y X 90.120-26

MODEL 42, 242, 61, 66, 266, 268, 281, 288

New pivot sleeve for chain brake in magnesium

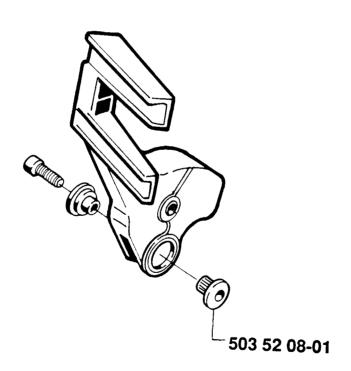
In order to improve the function on the chain brake, the left pivot sleeve is modified (made shorter).

New Ref. no. Description Excluded Ref. no. Remark 503 52 08-01 Pivot sleeve 501 76 81-01* See below

Ref. no. $503\ 52\ 08-01$ is included in chain brake compl. Ref. no $501\ 79\ 67-04$, $501\ 79\ 67-05$, $503\ 57\ 28-01$, $503\ 57\ 28-03$ and $503\ 57\ 94-02$.
